INDIANA DEPARTMENT OF TRANSPORTATION

MEMORANDUM

RE: Agenda for the January 20, 2005 Standards Committee Meeting

802-SNGP-05 Sign Data Tables

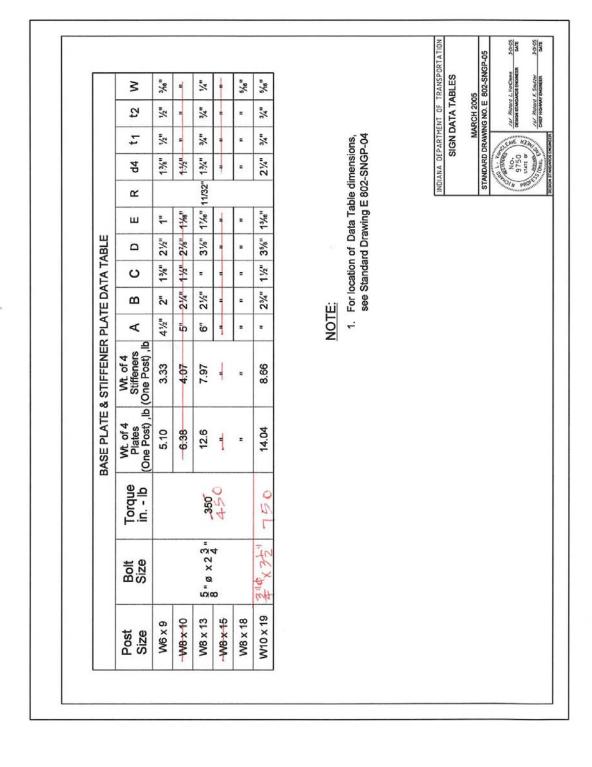
This revises the torque required for base plate & stiffener plates.

Wide Flange Base Plate Torque, Bolt Diameter, and Overhead Structure Bracing

We would like to make a revision on the above standards. We feel the current torque values are not structurally adequate and sound. Also the bolt diameters shown on March 1, 2005 CD are correct, but with one exception as shown in this revision. We submit these proposed details to the Spec. Committee for review and approval.

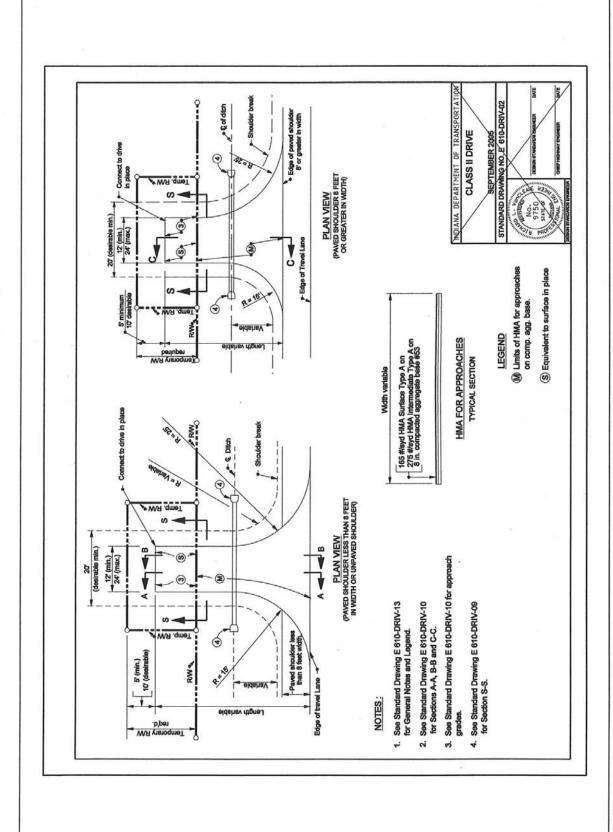
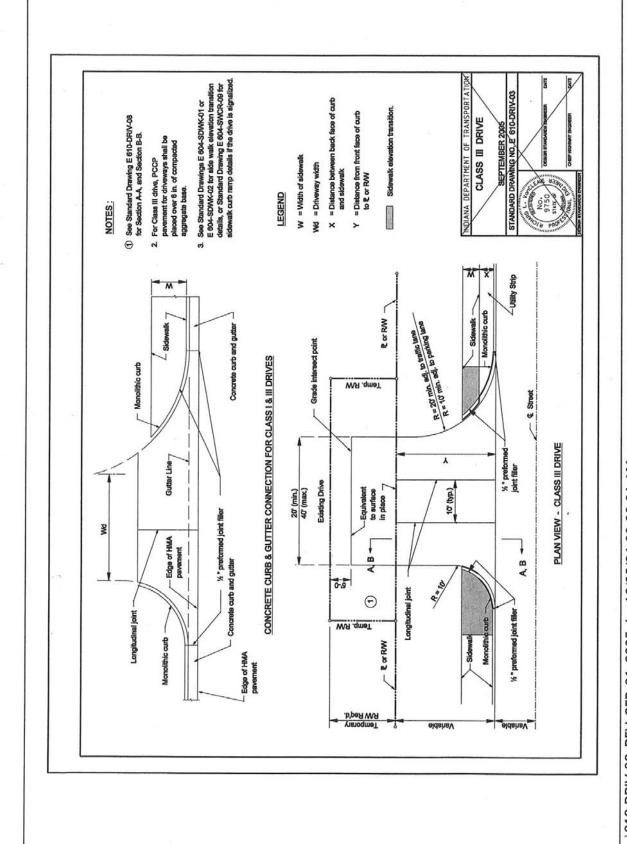
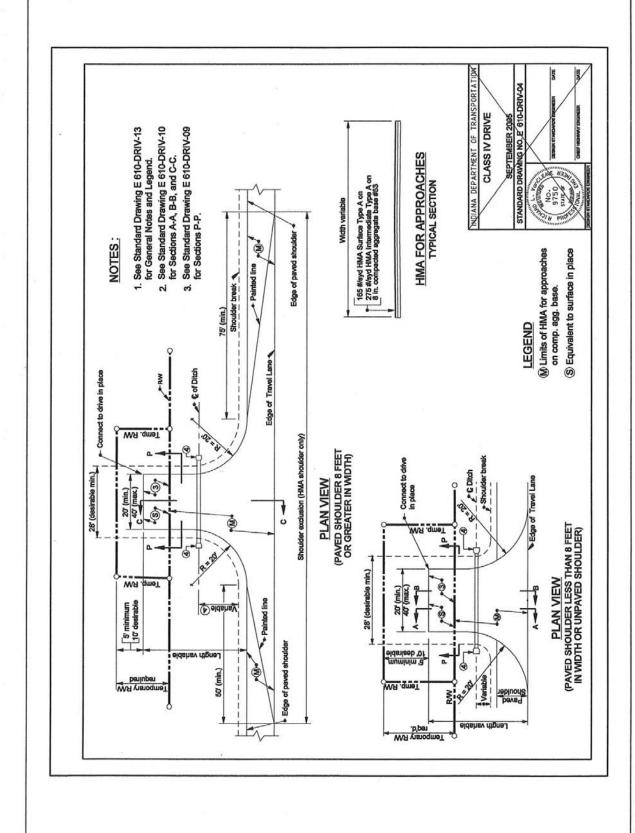
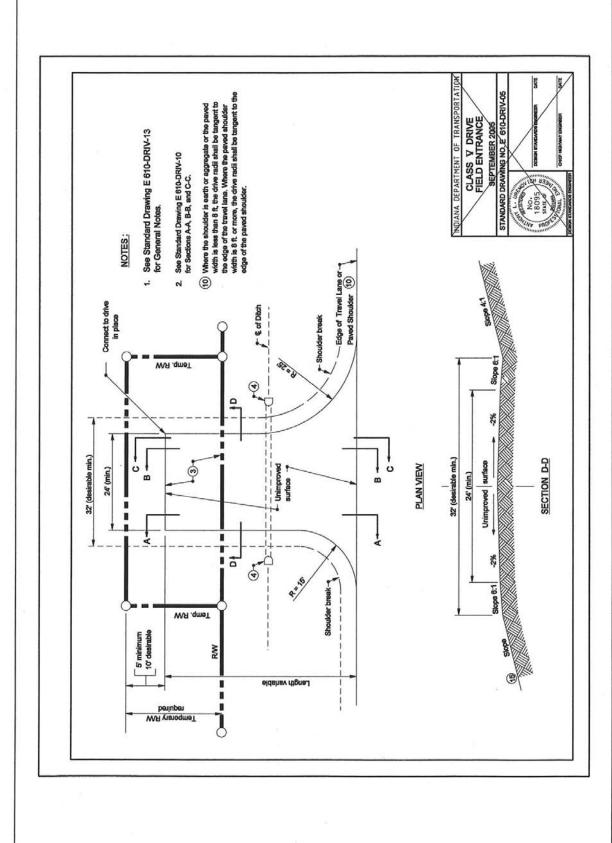
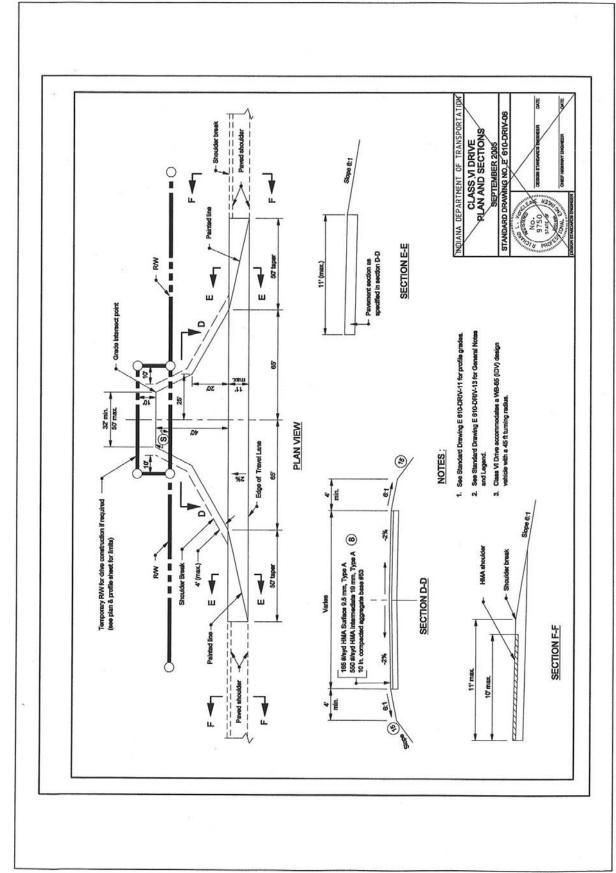
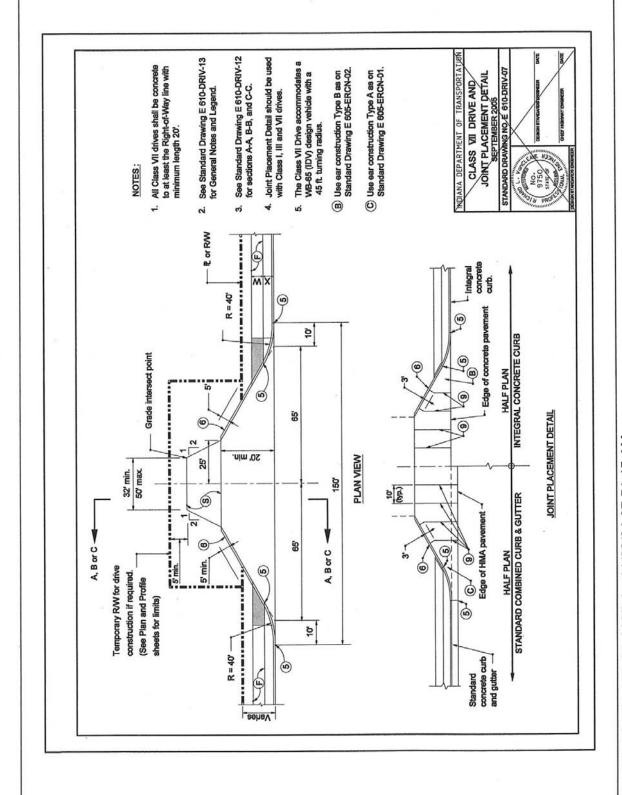
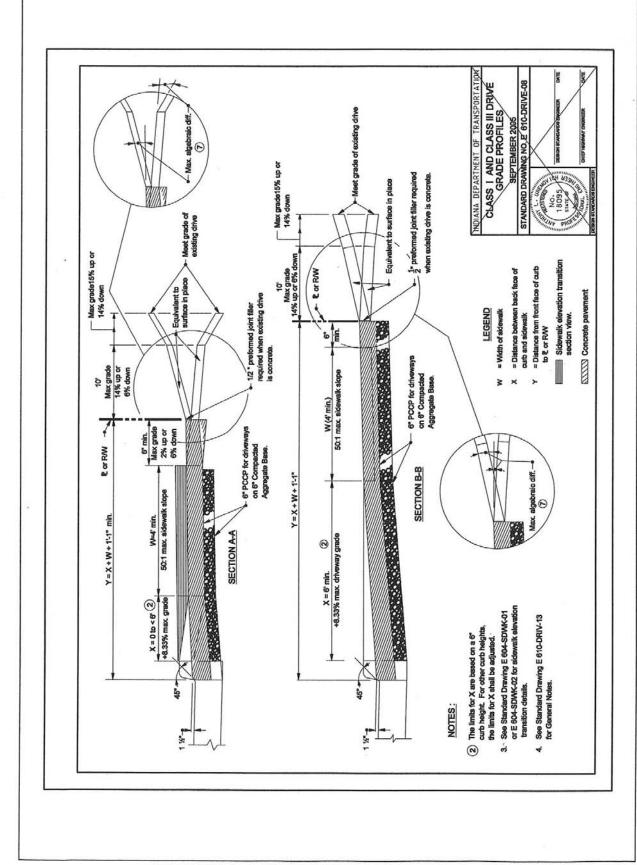
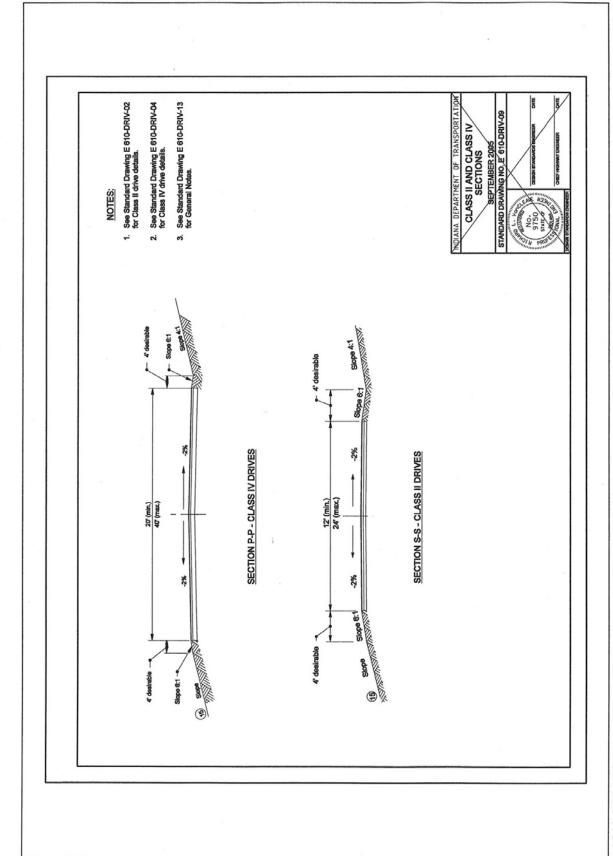
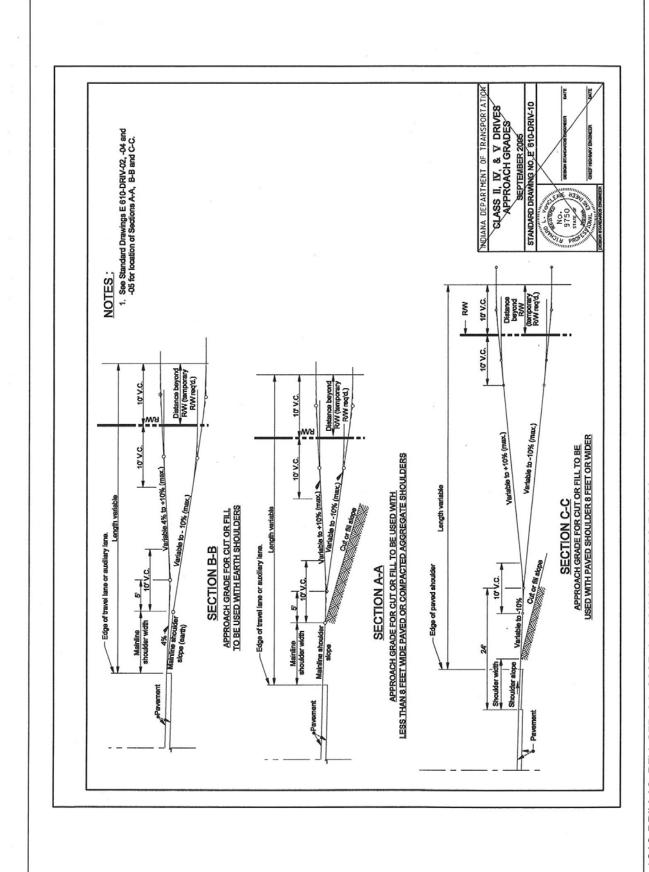
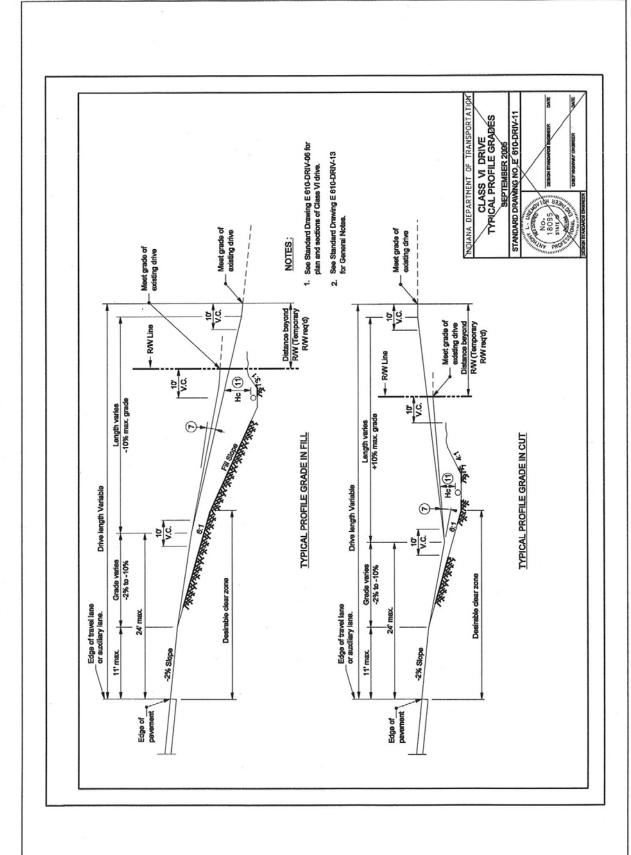
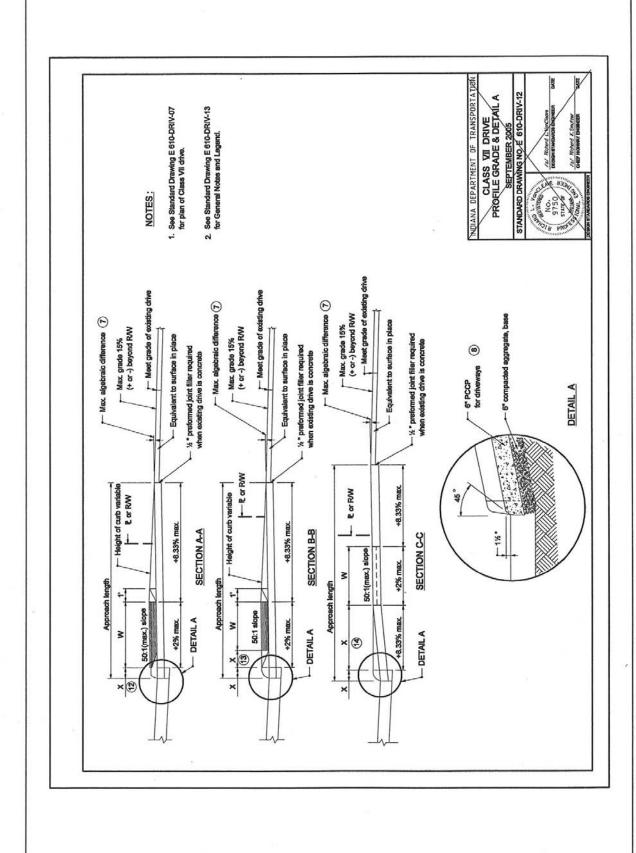
The above sheets have been rearranged since the last approval and the drive profile grades have been revised

802-SNWW-07 Sign Walkway Details

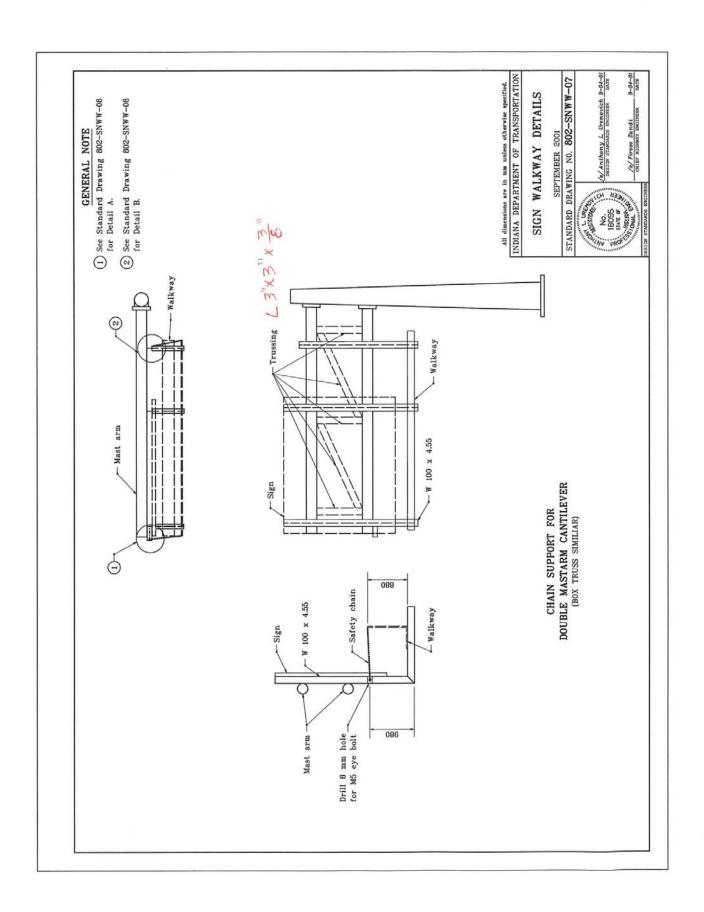
REVISION TO STANDARD DRAWINGS

801-TVDV-01 Channelizing Devices 801-TCDV-02 Channelizing Devices

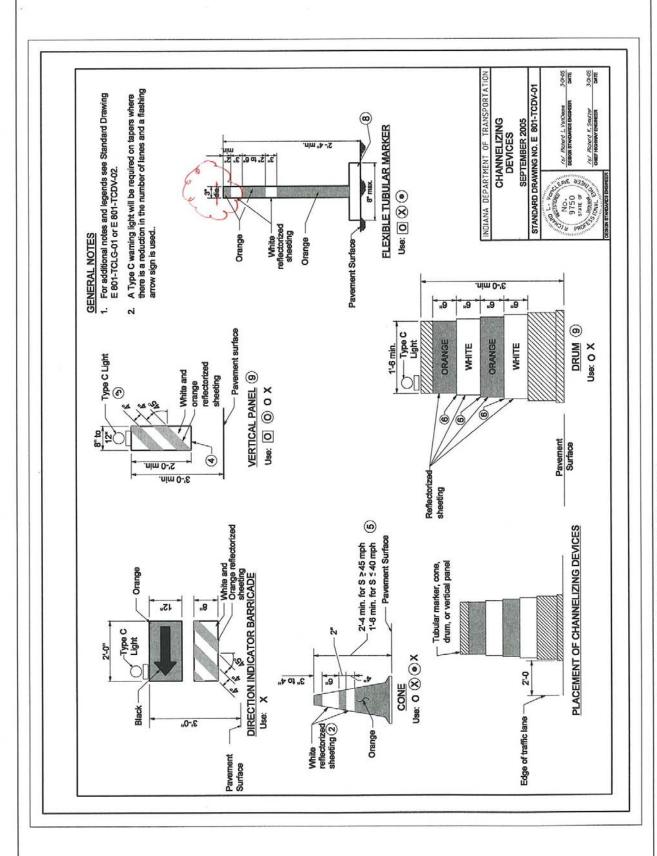
REVISION TO STANDARD DRAWING
